Technical Advisory Committee

Monday, May 6, 2024
1:30 PM

City of Hollywood

C. **Preliminary Site Plan Review**

Sheet No.
C-5.4

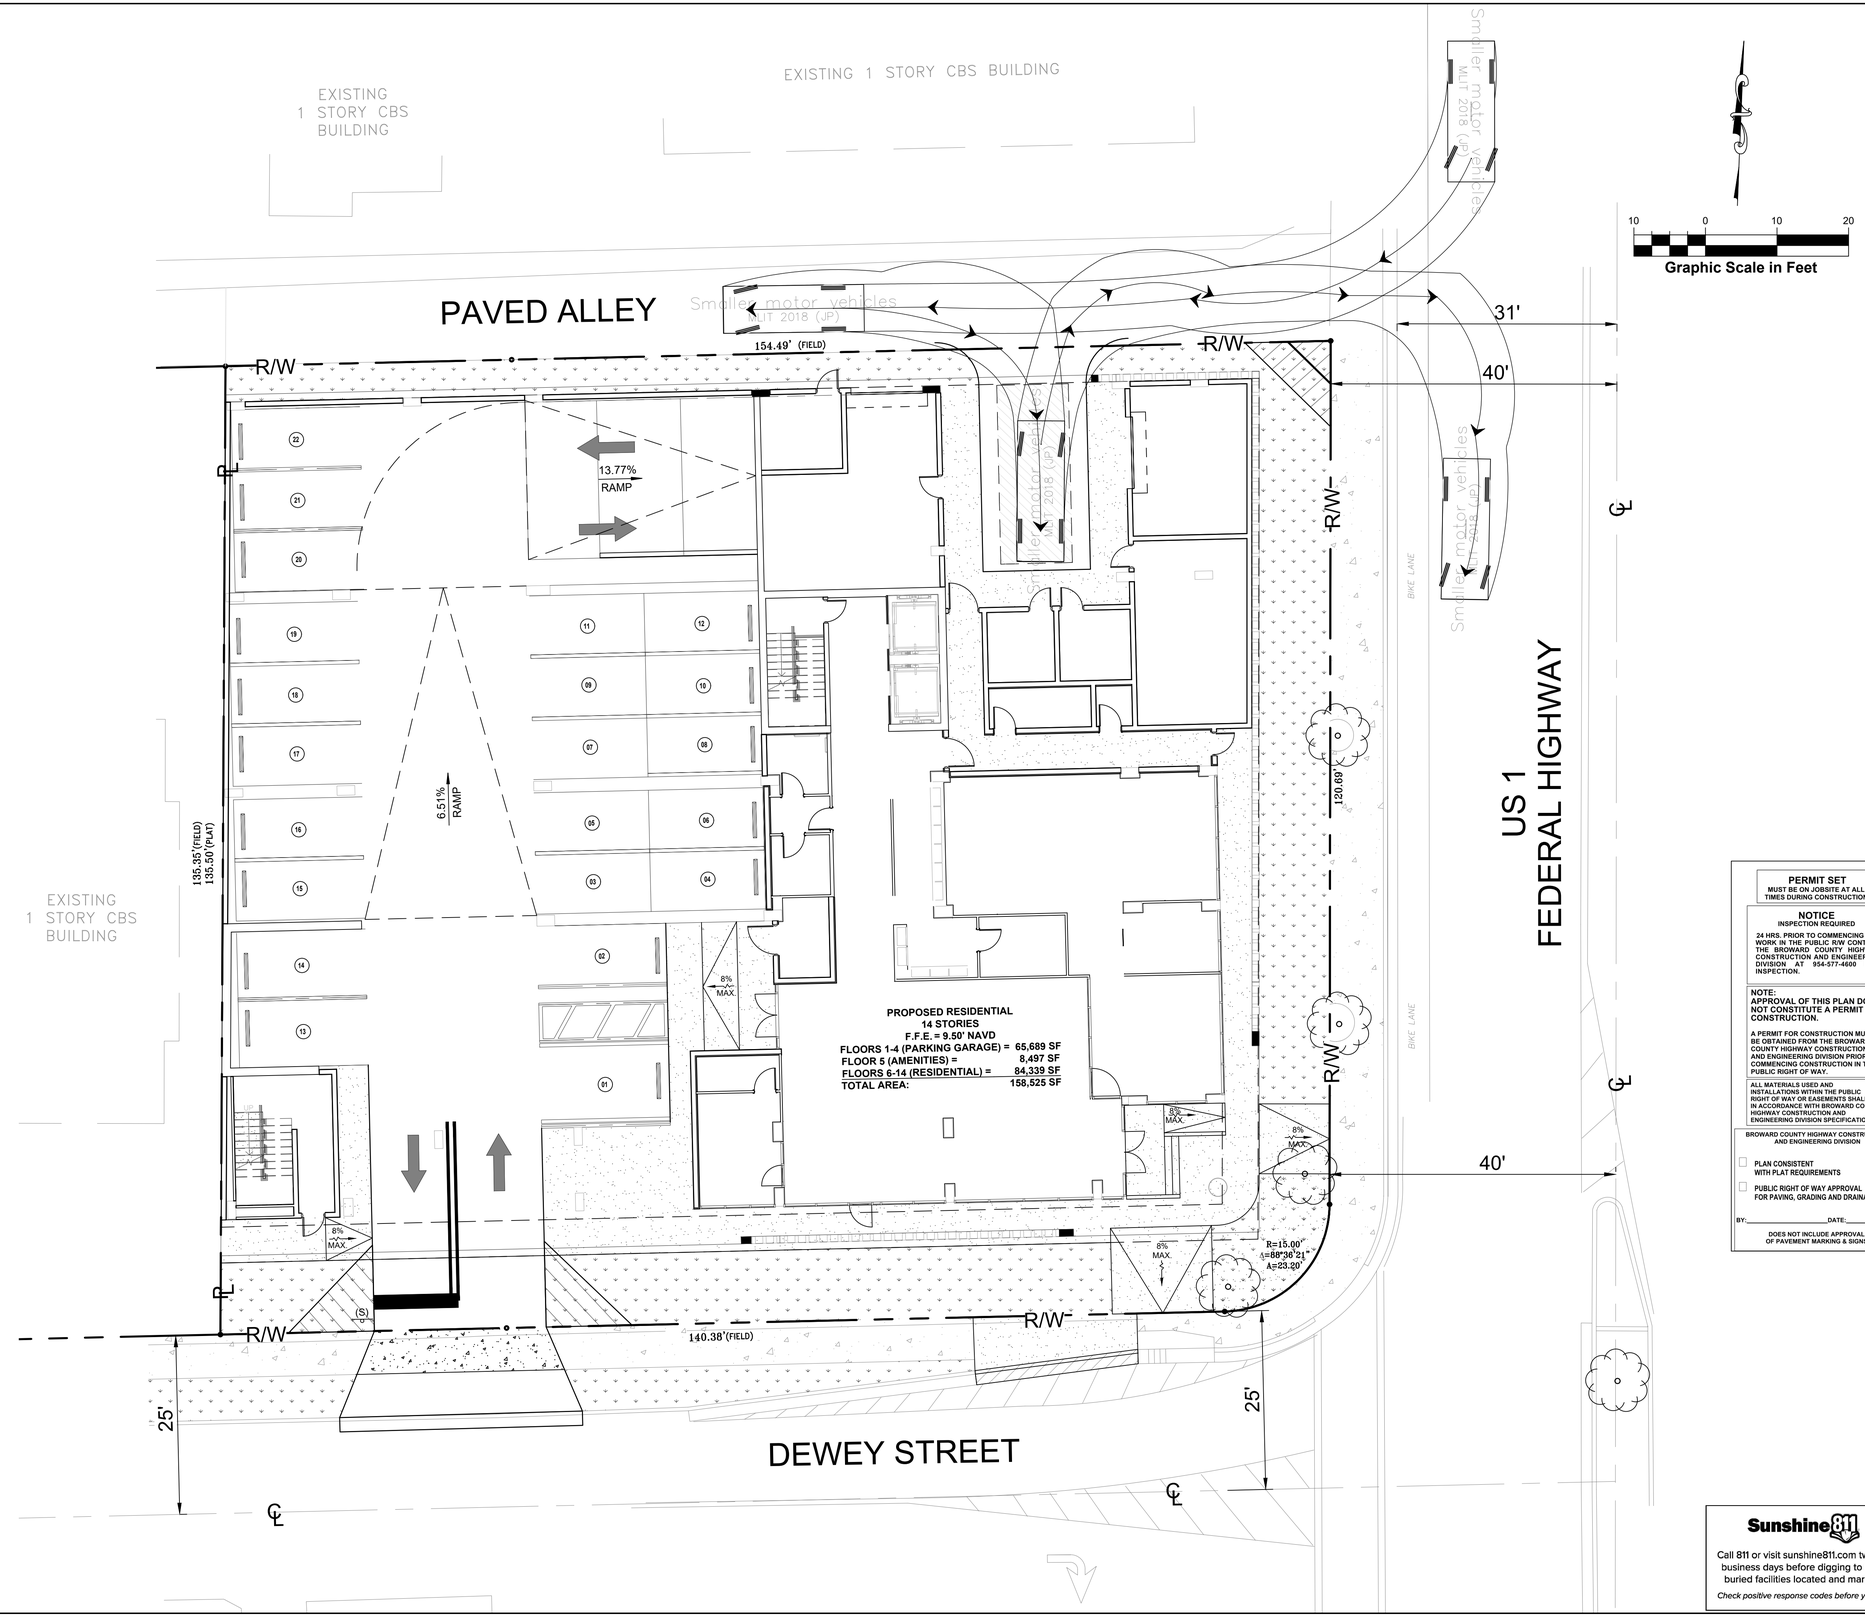
Response:
    It has been revised as per the review comment
    Auto Turn analysis has been provided in Sheet 5.4 Loading Access Plan

Sheet No.
C-10.0

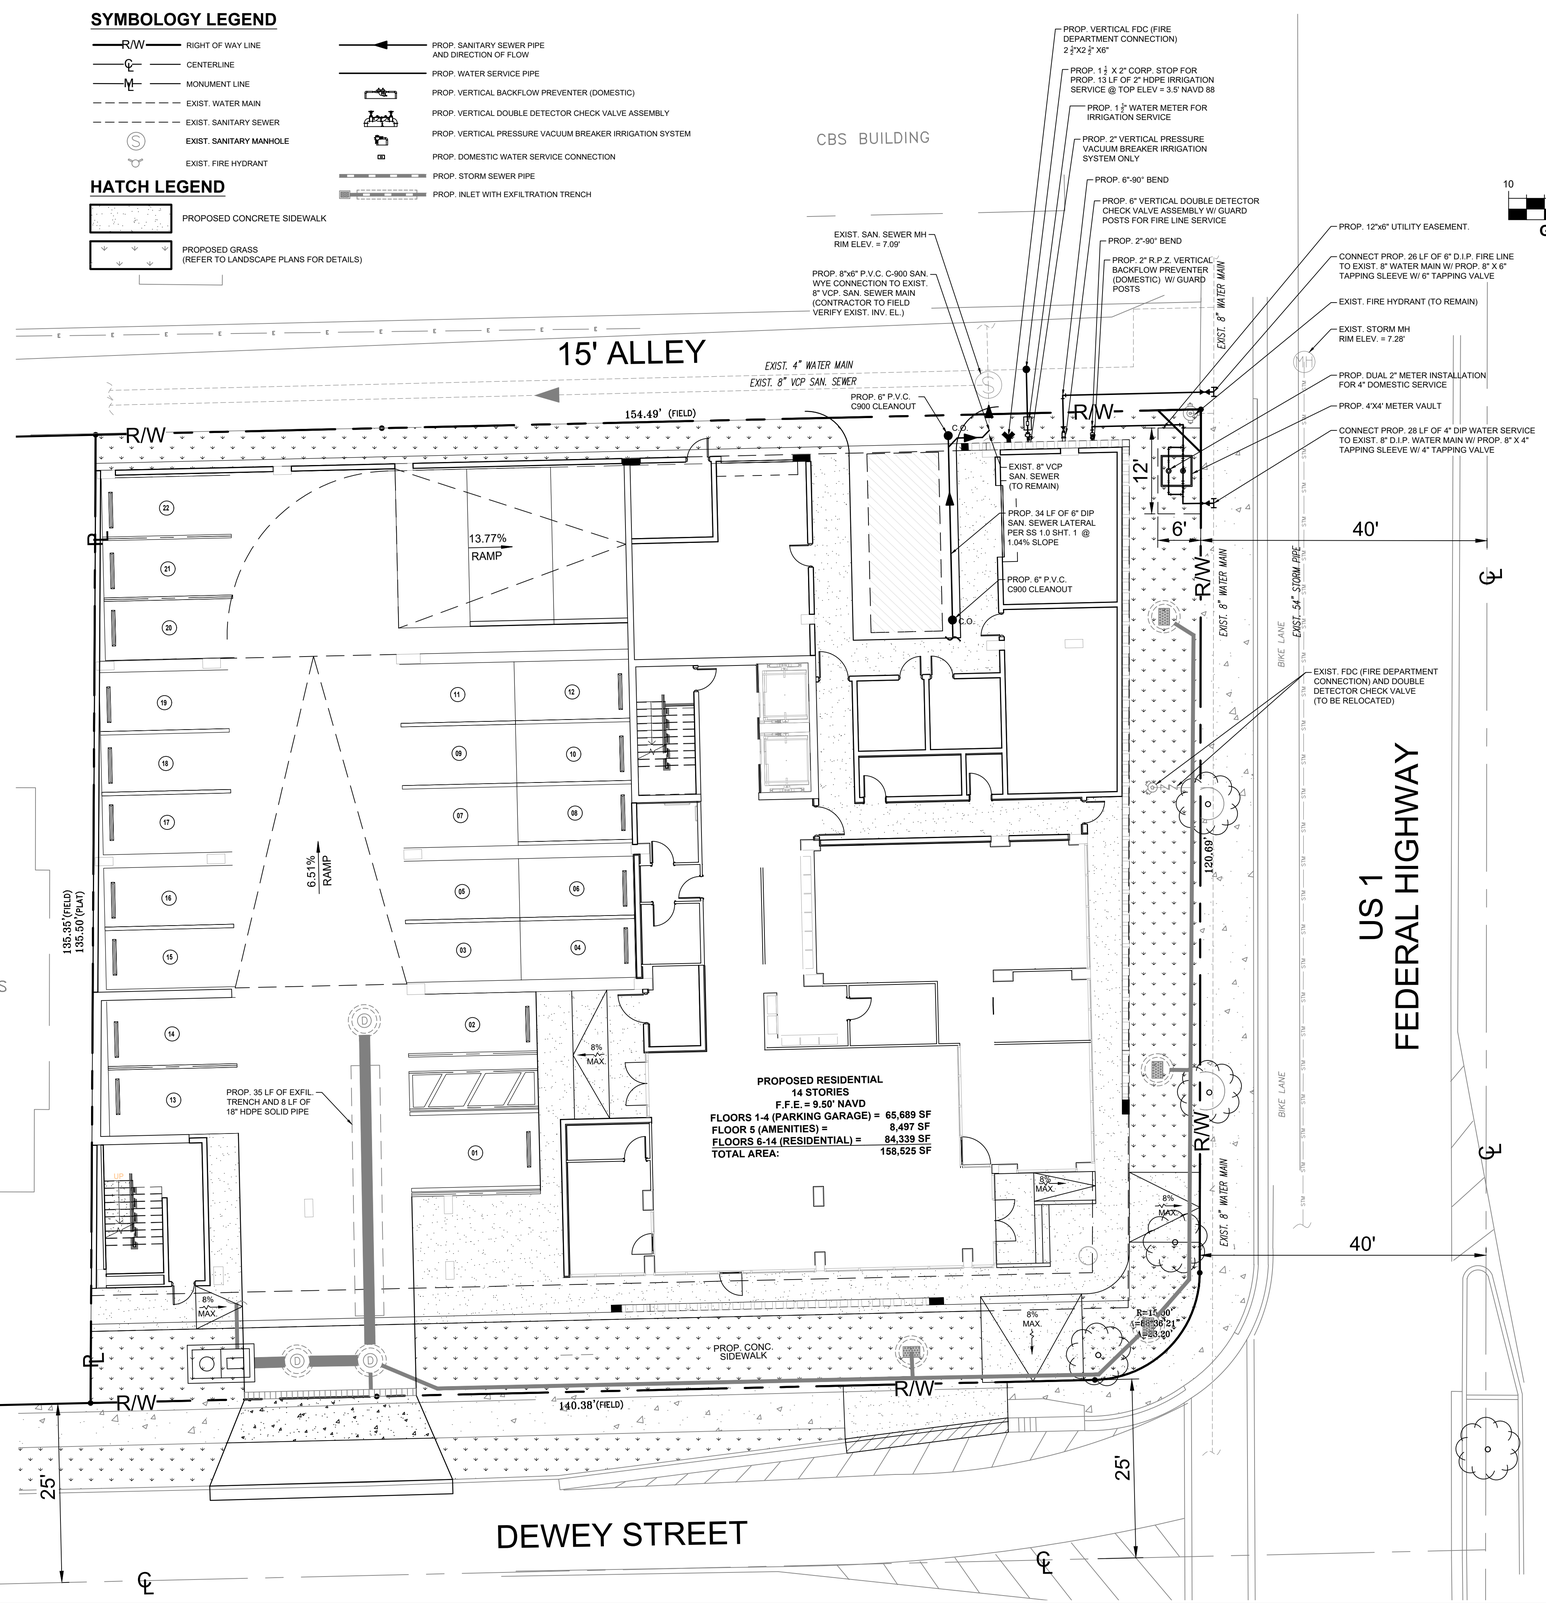
Response:
    Acknowledged. Note has been added. Please refer to sheet C-10.0 Utility Connection Plan.

Response:
Note has been added. Please refer to sheet C-10.0 Utility Connection Plan.

Response:
Note has been added. Please refer to sheet C-10.0 Utility Connection Plan.
